# DEVELOPMENT REVIEW BOARD REPORT

### **Primrose at Windgate Crossing**

#### **25-DR-2016**

**Request:** Request approval of the site plan, landscape plan, and building elevations for a new commercial building for child day care, with approximately 11,600 square feet of building area on an approximately 0.83-acre pad site within the 7.8-acre Windgate Crossing shopping center.

SHEET TITLE  
PRELIM.  
EXT. ELEV'S.

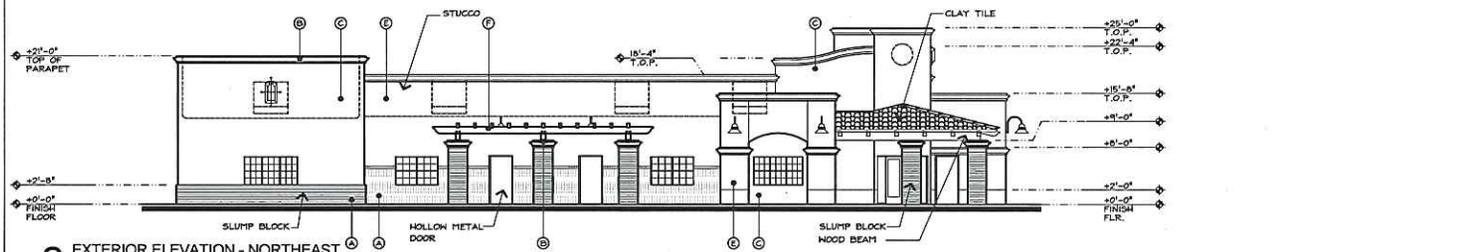
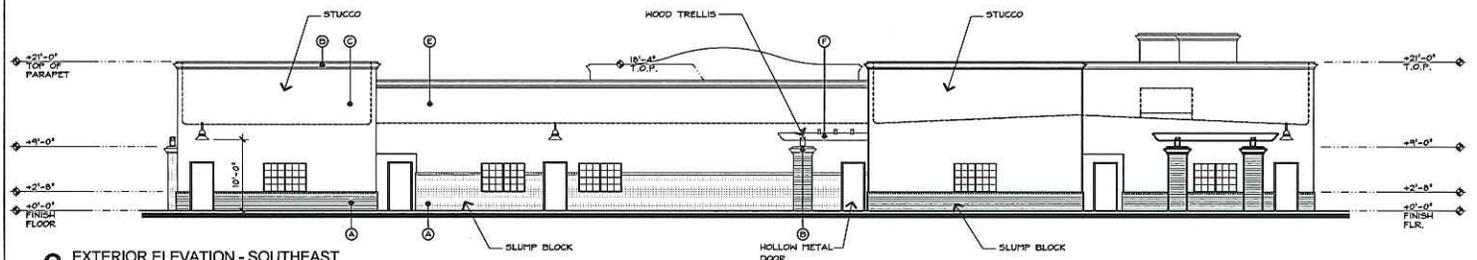
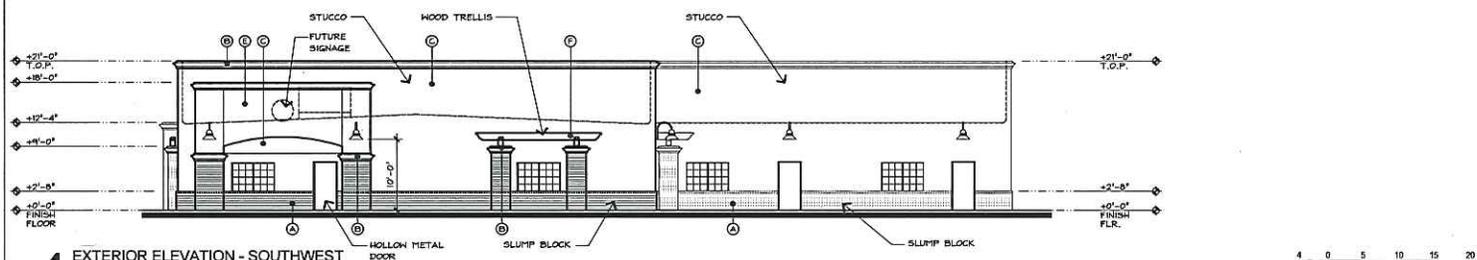
4. Several windows on the East, South, and West sides of the building appear to be unprotected from solar exposure, heat gain, and to minimize reflected heat. Please provide exterior shade devices for these windows and/or provide illustrations that demonstrate how proposed roof overhangs, canopies, and other exterior design elements provide shade for these windows. All shade devices should be designed so that the shade material has a density of 75%, or greater, in order to maximize the effectiveness of the shade devices.
